ORIGINATION FORM

Proposed Revisions to a Standard Plans Index

Index Number: 446-001

Index Title: Concrete Pavement Subdrainage

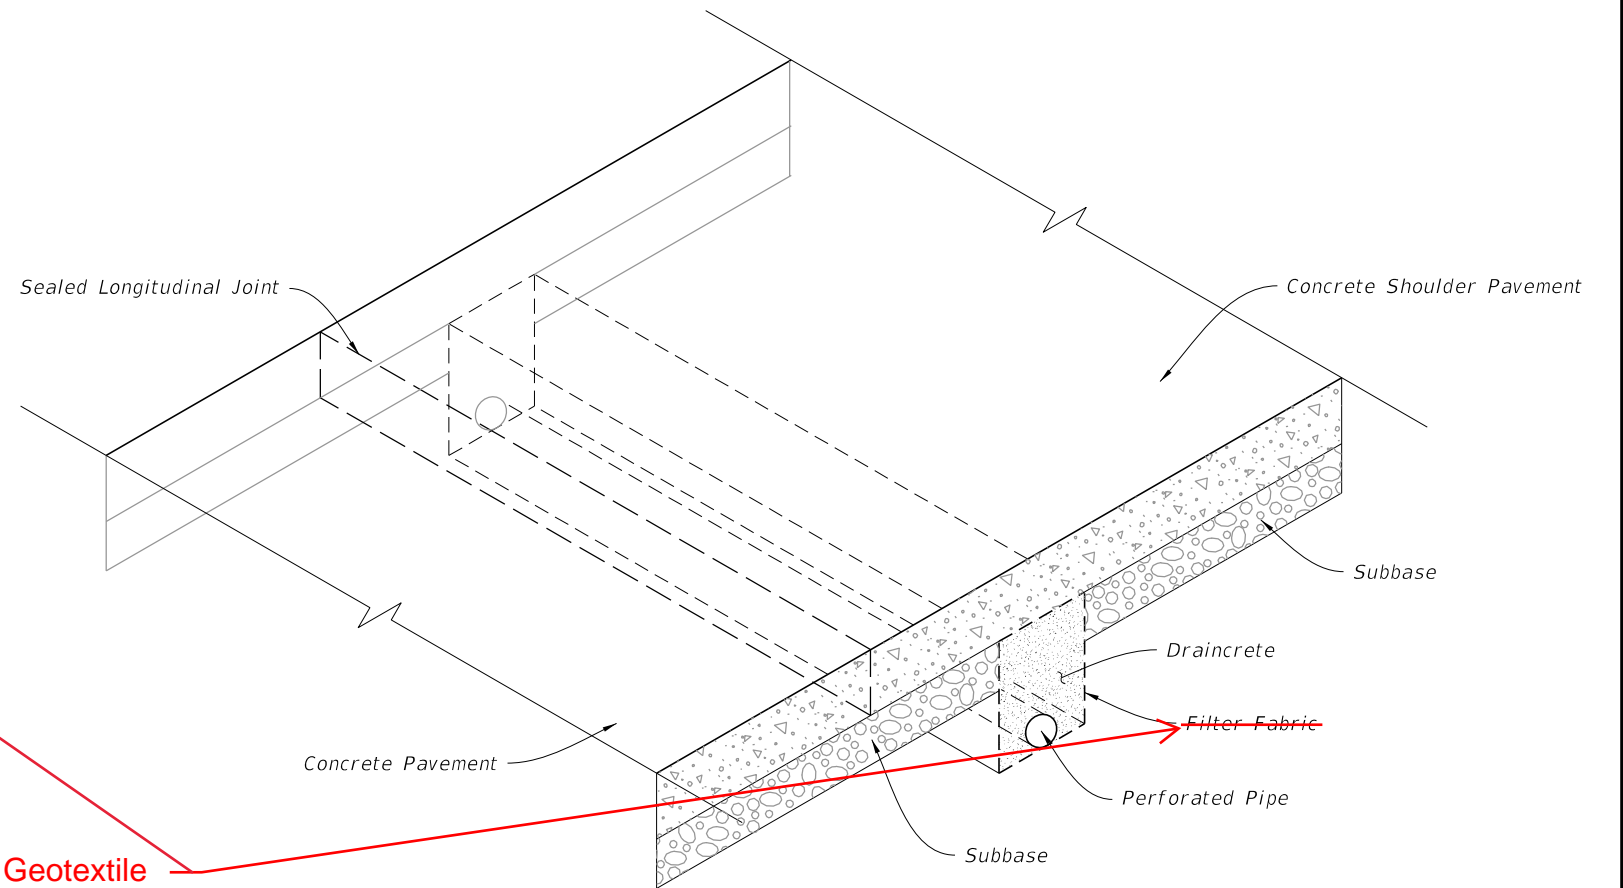
Sheet 1: Updated Note 4 "Provide and install Type D-3 geotextile in accordance with Specifications 514."
Changed all references of "Filter Fabric" to Geotextile.

UPDATED Note 4:
Provide and install Type D-3 geotextile in accordance with Specifications 514.

CHANGED: Geotextile

CONCRETE SHOULDERS AND AUXILIARY PAVEMENT

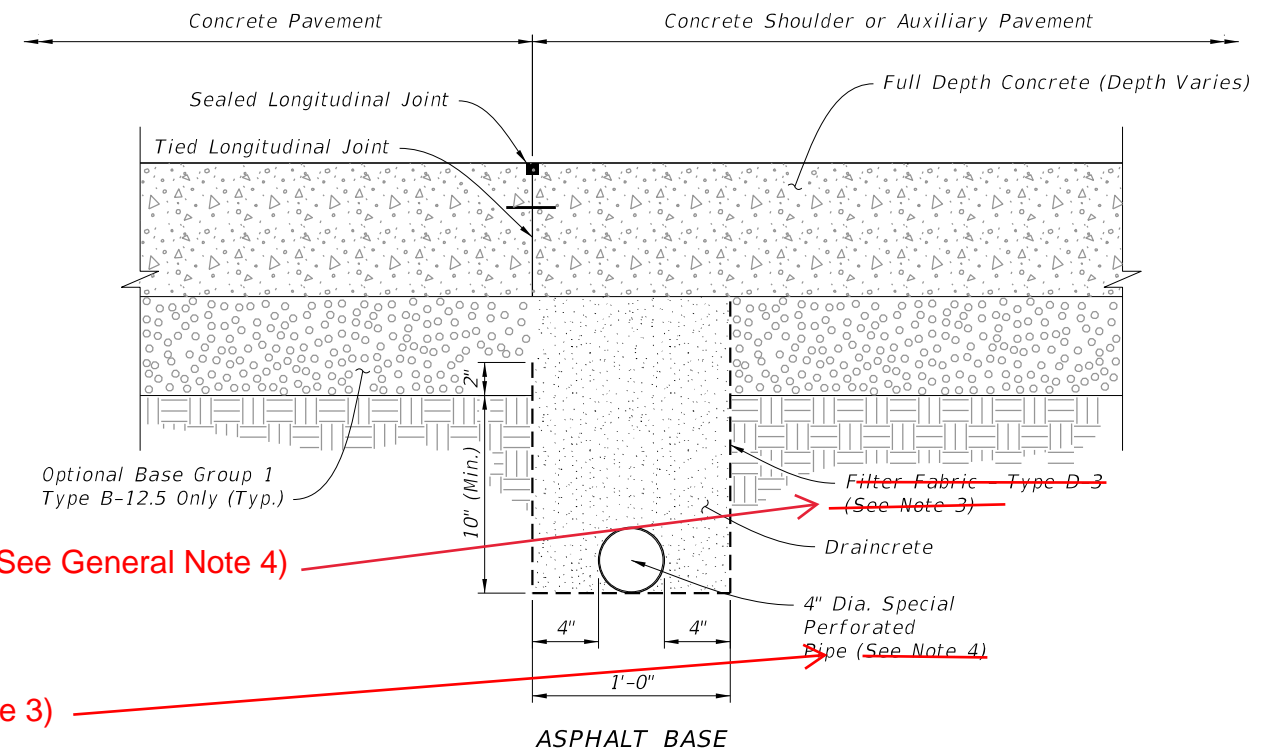
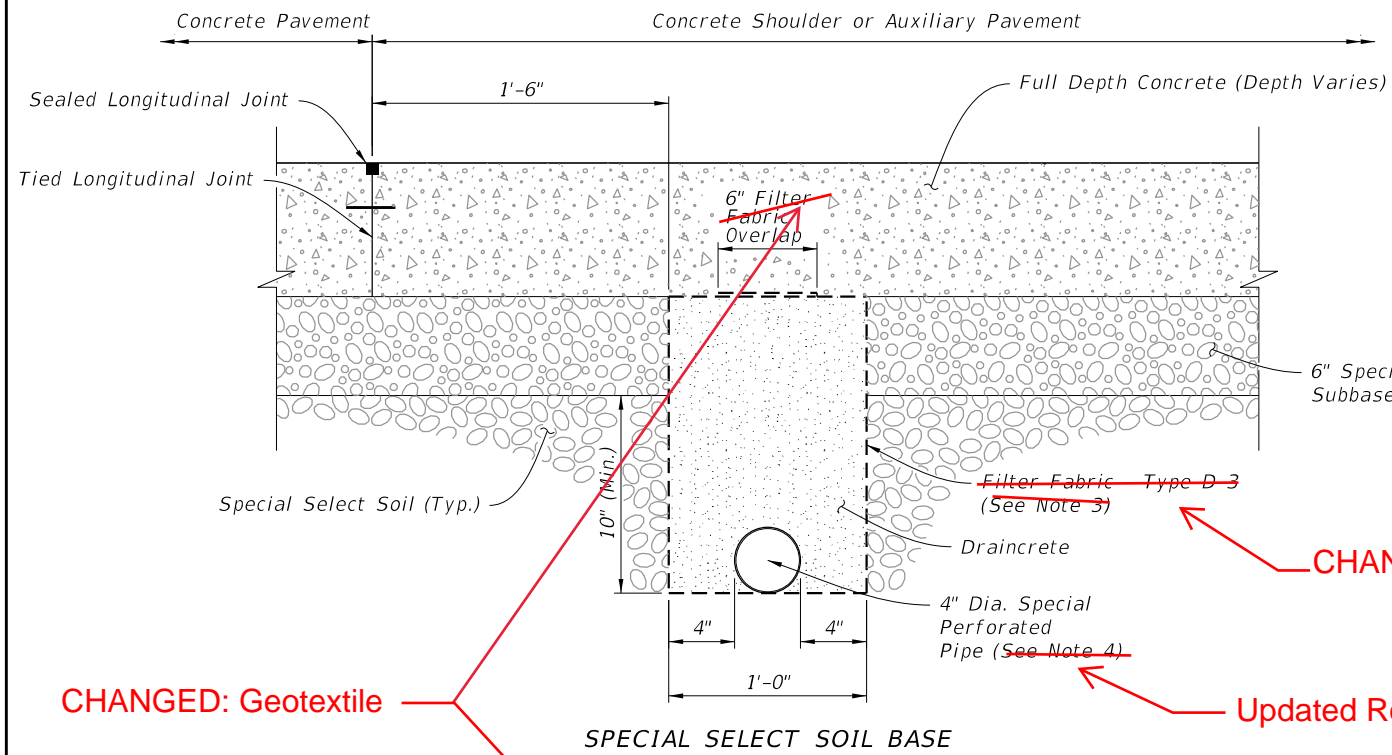
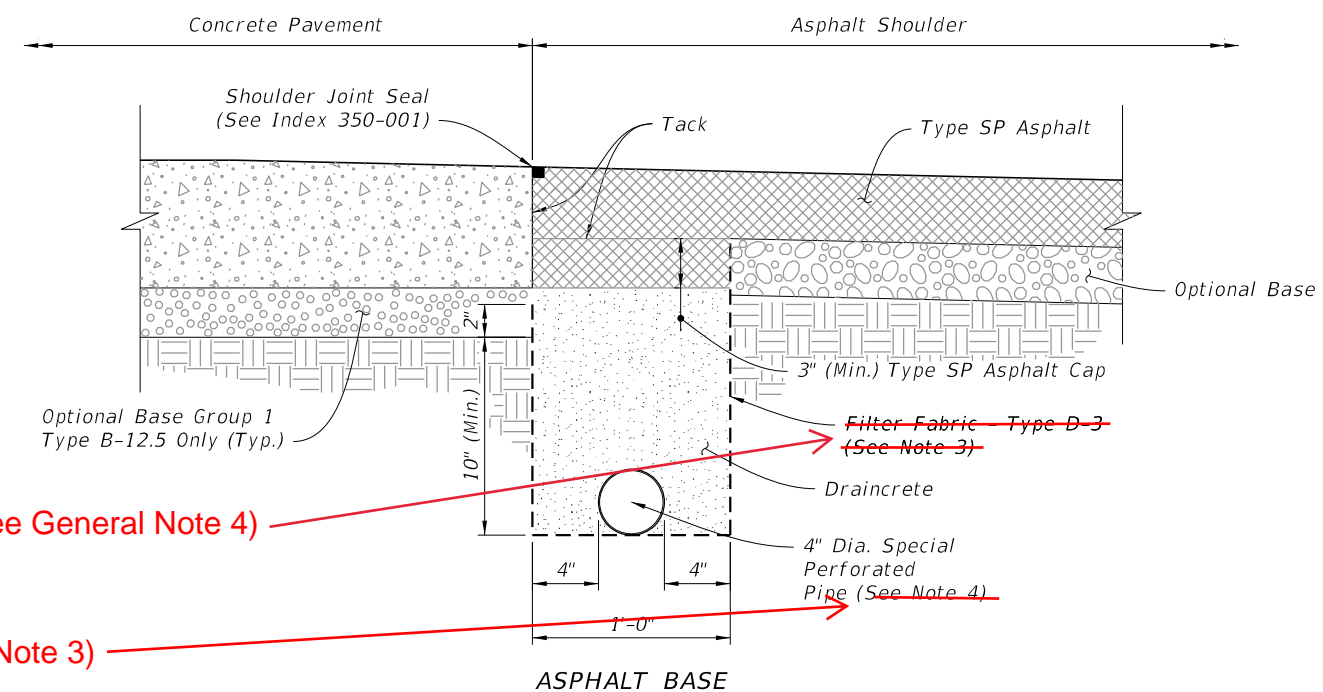
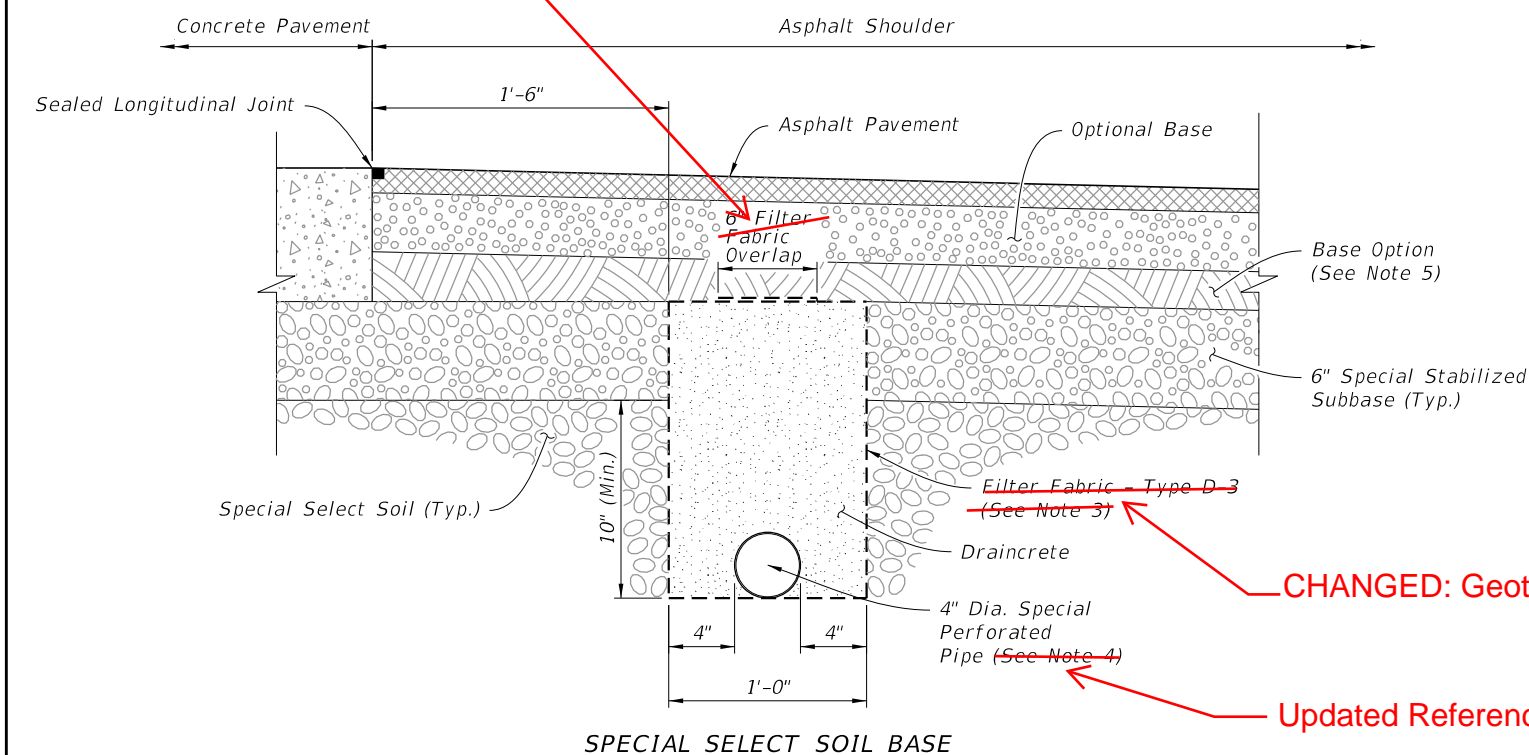
Sheet 3: Moved Note 3 to General Note 4 on Sheet 1; Renumbered Notes; Updated Note references in callout;
Changed all references of "Filter Fabric" to "Geotextile".

CHANGED: Geotextile

CHANGED: Geotextile (See General Note 4)

Updated Reference: (See Note 3)

CHANGED: Geotextile (See General Note 4)

Updated Reference: (See Note 3)

NOTES: Renumbered Notes

EXISTING SHOULDERS

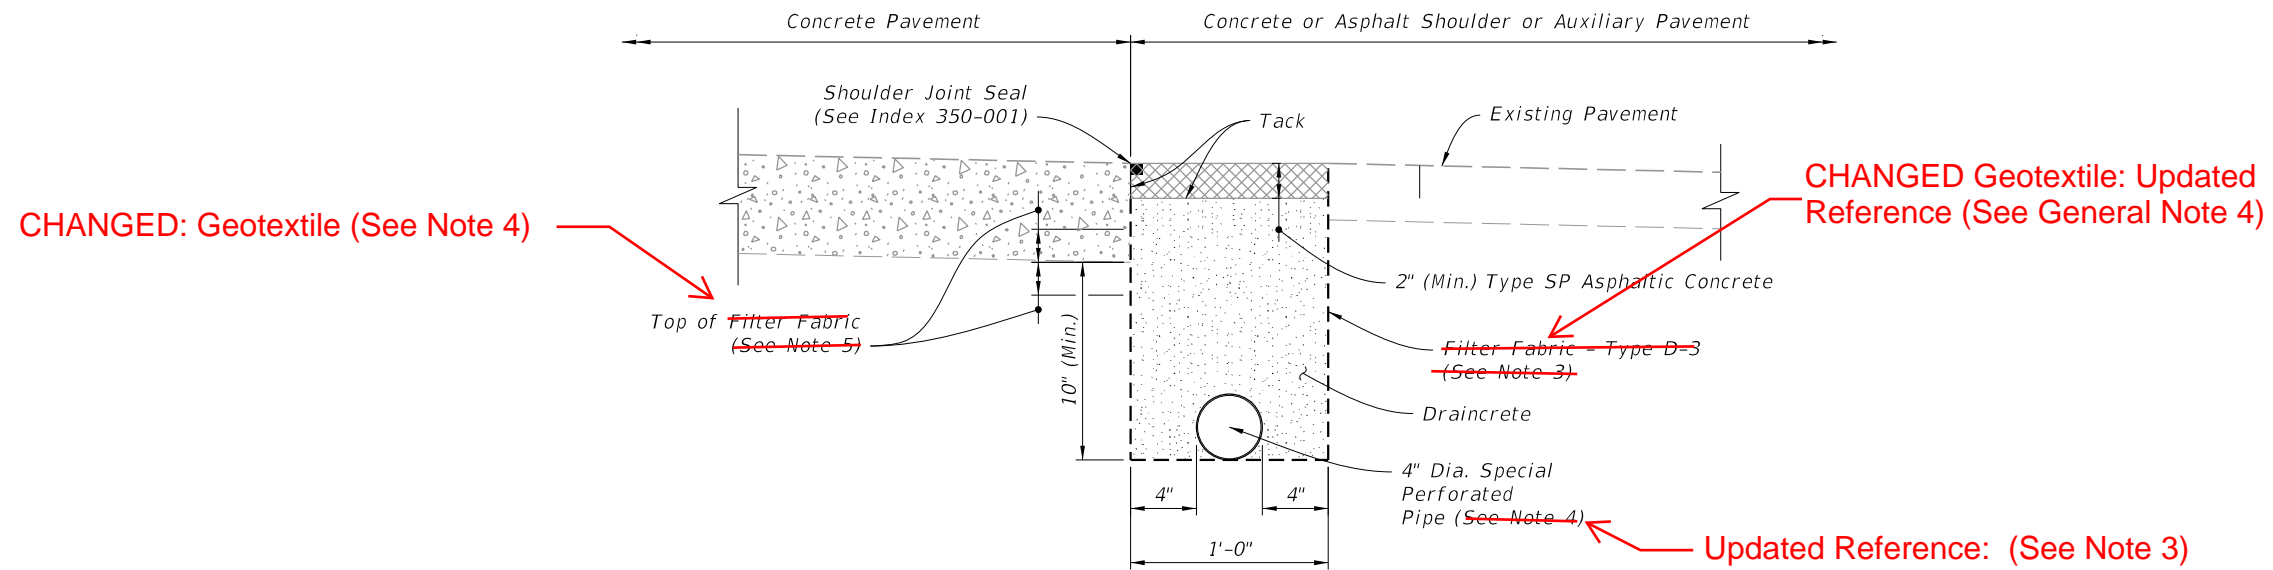
Sheet 4: Moved Note 3 to General Note 4 on Sheet 1; Renumbered Notes; Updated Note references in callout;
Changed all references of "Filter Fabric" to "Geotextile".

CHANGED: Geotextile (See Note 4)

CHANGED Geotextile: Updated Reference (See General Note 4)

Updated Reference: (See Note 3)

Renumbered Notes

CHANGED: Geotextile
